Our ref: 19688

18 December 2019

RE: Submission – Sydney Gateway Road Project (SSI-9737)

Figure 2 - Proposed Intersection Layout - Terminals 2/3 Ingress

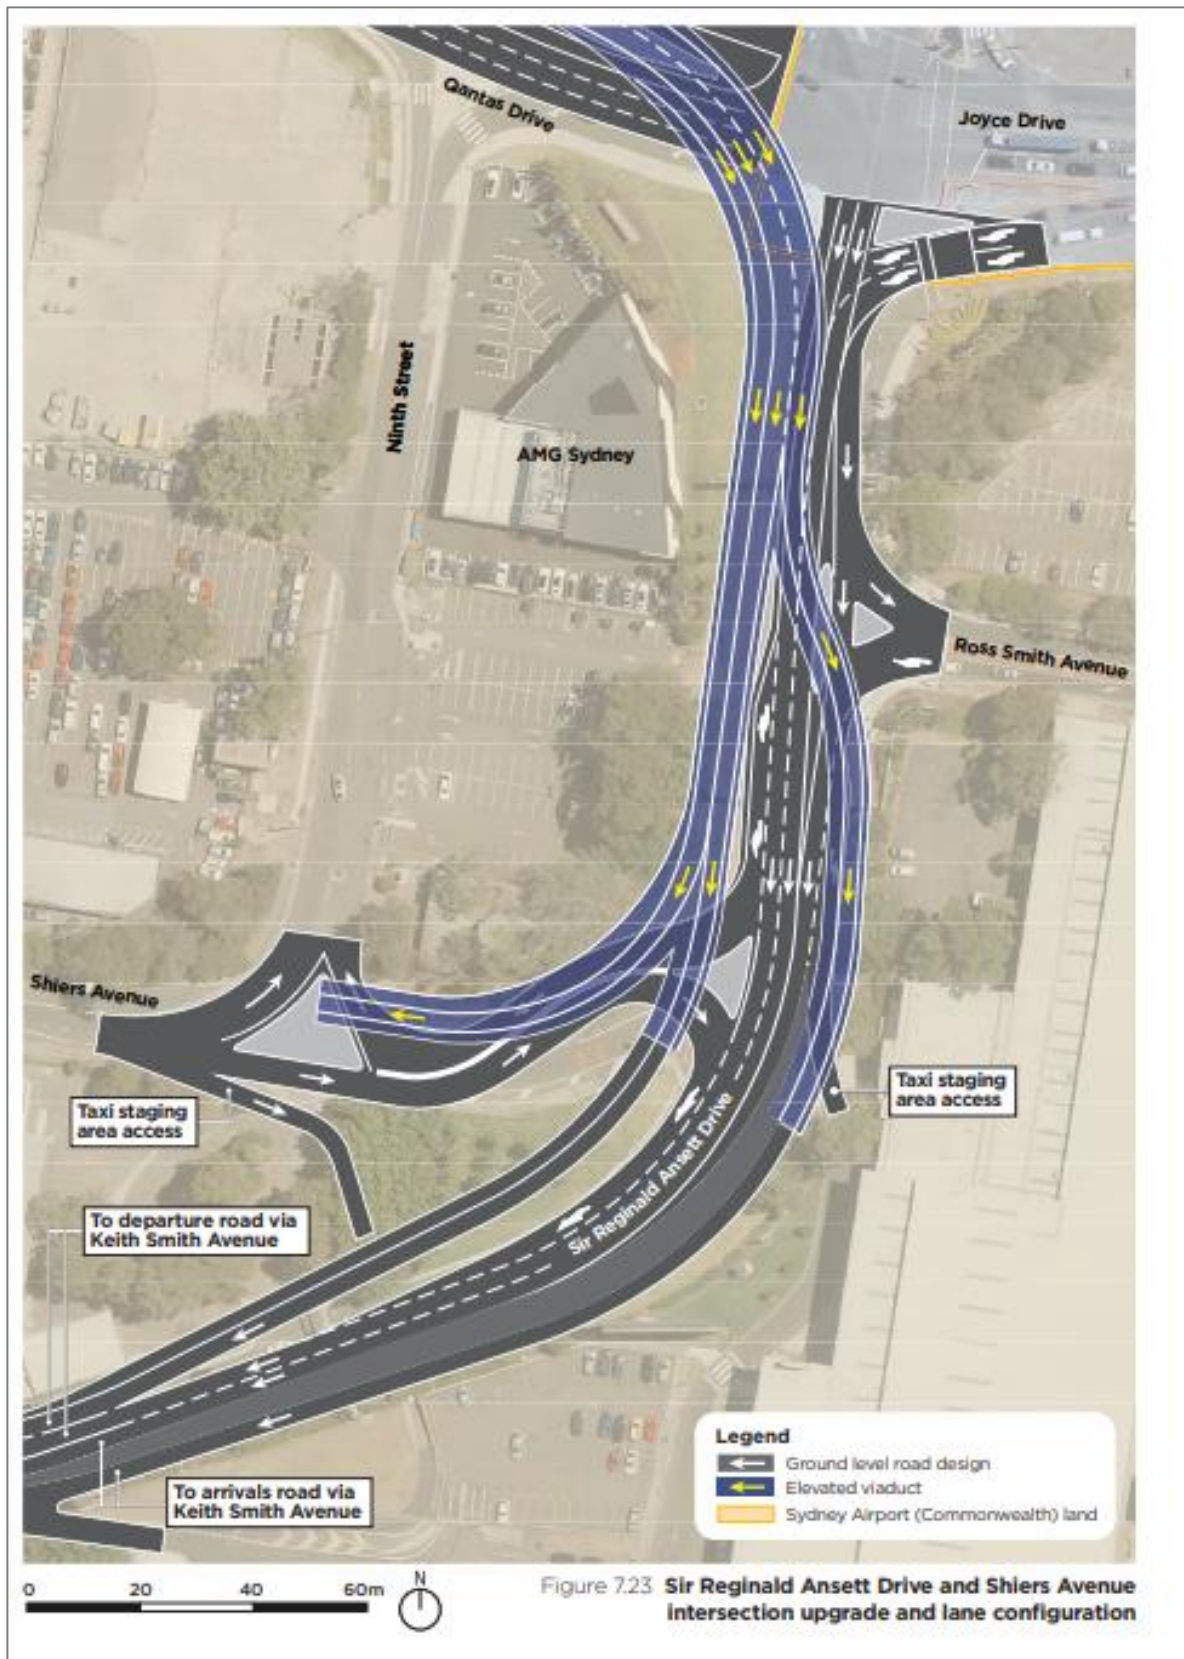
The proposal has not acknowledged that currently all traffic entering the Terminals 2/3 access point passes the intersection of Sir Reginald Ansett Drive and Ross Smith Avenue. The current arrangement facilitates access to the McDonald's for the passing trade arriving to the terminal. Motorists leaving the airport can also access the McDonald's by traveling east on Qantas Drive, and utilising the right hand turn into Sir Reginald Ansett Drive.

- + The proposed elevated overpass connecting Terminals 2/3 with the upgraded Qantas Drive terminates after the intersection of Sir Reginald Ansett Drive and Ross Smith Avenue. Consequently, a significant catchment of passing trade will not be in a position to access the businesses along Ross Smith Avenue in a convenient fashion.
- + The ability for east bound traffic on Qantas Drive to turn right into Sir Reginald Ansett Drive is unclear. Should traffic movement be restricted in this regard, it further restricts the ability for passing trade, including east bound motorists leaving Terminals 2/3 from being able to access the McDonald's via Sir Reginald Ansett Drive and Ross Smith Avenue.

- + The existing right hand turn from Qantas Drive into Sir Reginald Ansett Drive be maintained. The congestion currently experienced at this intersection will be alleviated by the creation of the overpass. It is considered that this right hand turn can be maintained in the amended traffic environment.

- + Consideration should be made to providing a direct access from Joyce Drive for the existing restaurants in the Ross Smith Avenue precinct.
- + Consideration should also be made for a direct exit from the overpass road onto Ross Smith Ave. The projected overpass road feeds into the Domestic terminal via a series of ramps which feed traffic directly to different sections (Car Park; Arrivals; Departures etc) however there is no opportunity to access Ross Smith Ave. Ross Smith Ave has two hotels in addition to the freestanding restaurants and it is important to provide vehicles an opportunity to access Ross Smith Ave via the overpass.
